REMARKS

U.S. Patent Application No. 10/685,009

Entitled: IMPROVED VEHICLE COMPONENT

CENTERING SYSTEM FOR VEHICLE SERVICE DEVICES

FIG. 7B

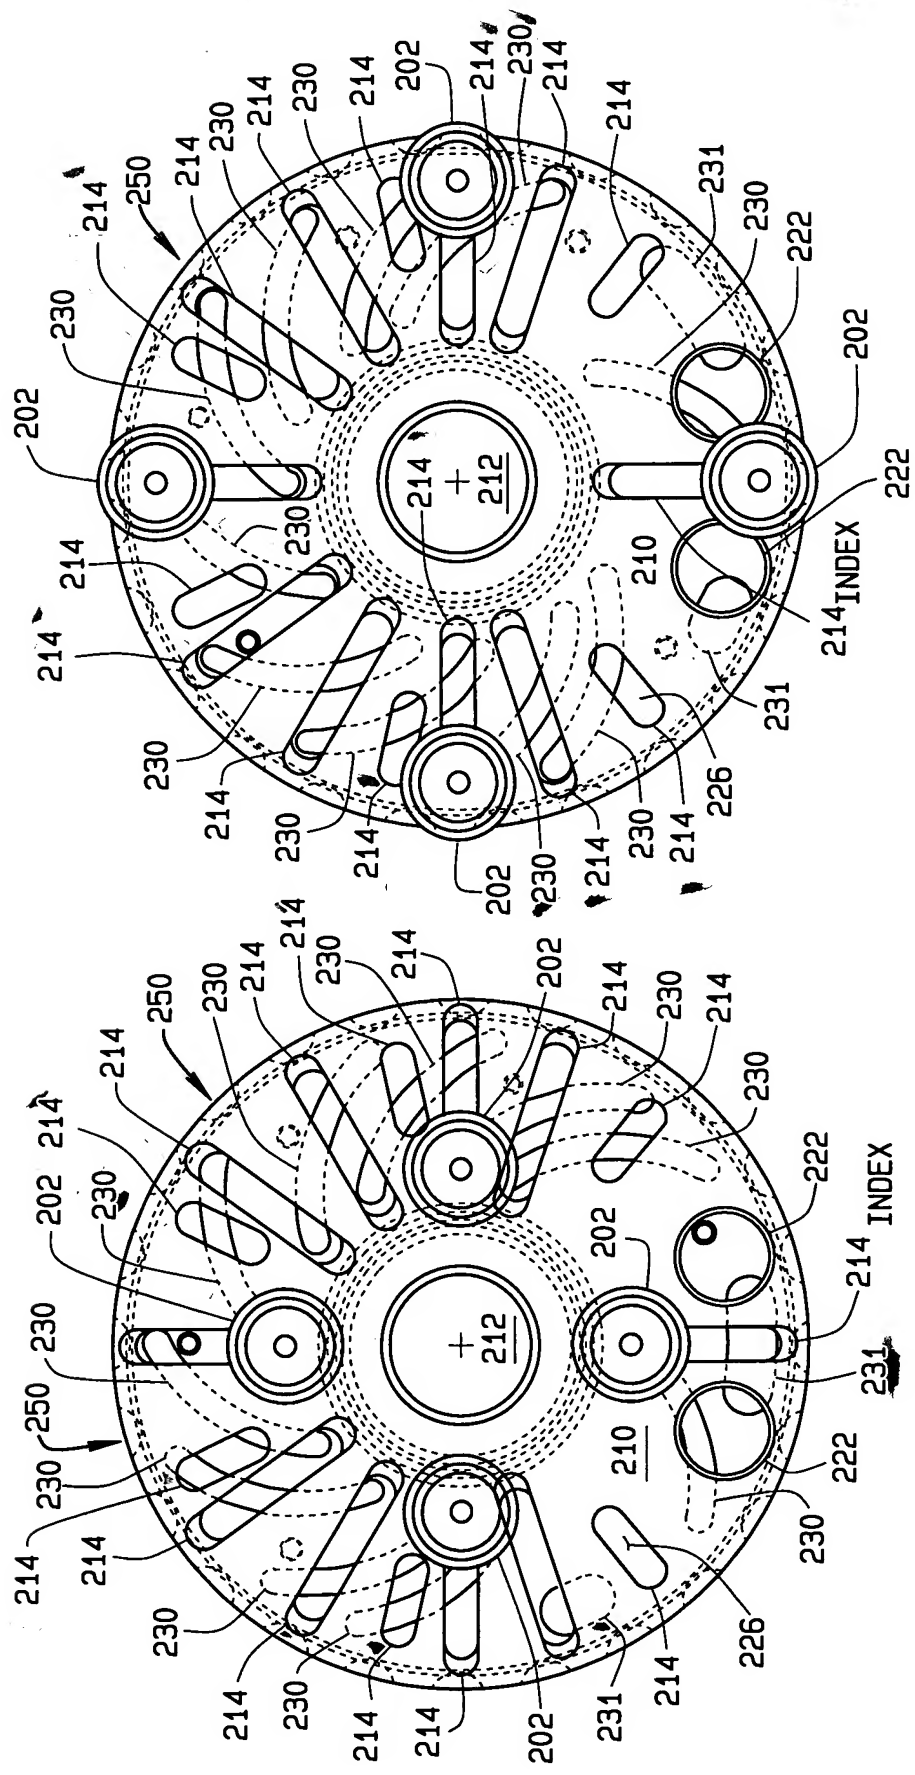
The Examiner has objected to the drawings under 37 CFR 1.83(a) as failing to show every feature of the invention specified in the claims. Specifically, the Examiner has stated that identifying indicia must be associated with *each of the slots*, or the features cancelled from the claims.

The drawings have been amended such that an identifying indicia is associated with each illustrated slot. Specifically, additional identifying indicia have been added to Figures 7A, 7B, and 16 where appropriate to identify unlabelled slots. A clean set of the amended drawings and a marked up set illustrating the changes made have been provided.
